# ADDENDUM No. 1

## RFP No. 18-10

### 2018 WTP Architectural and Structural Repairs

Figure 1 – Administration Building (Lower Level)

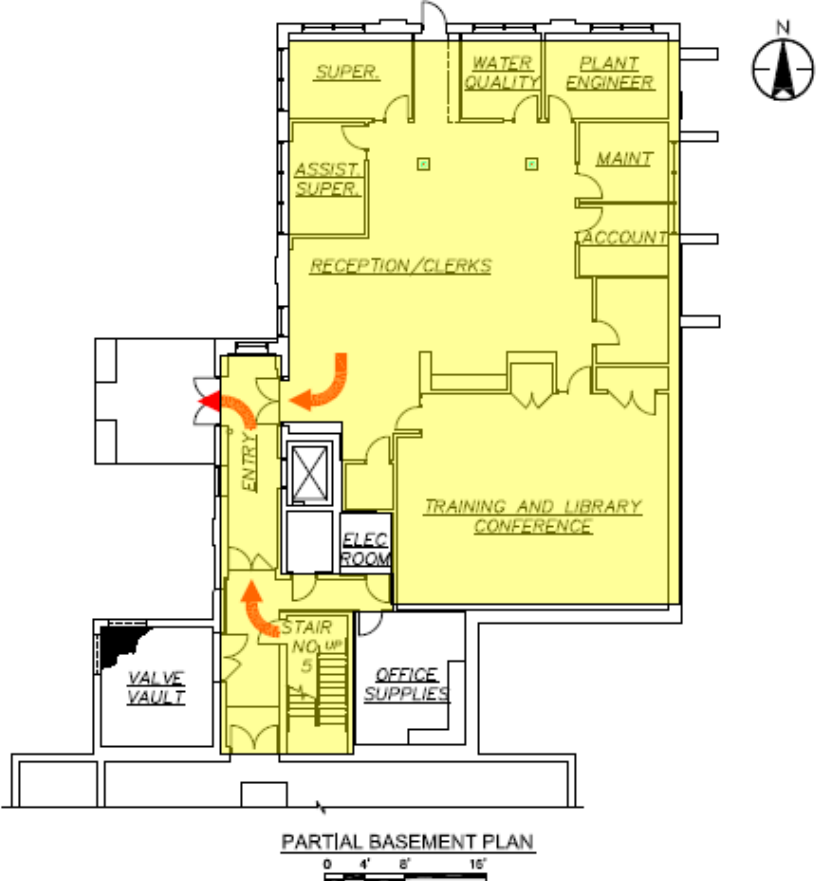
Q08: Please verify the areas shown in the image below are the areas for the interior design services.

A08: *See the figure below highlighting areas for interior design services in yellow. The bathroom in the reception area and the stairwell is included.*
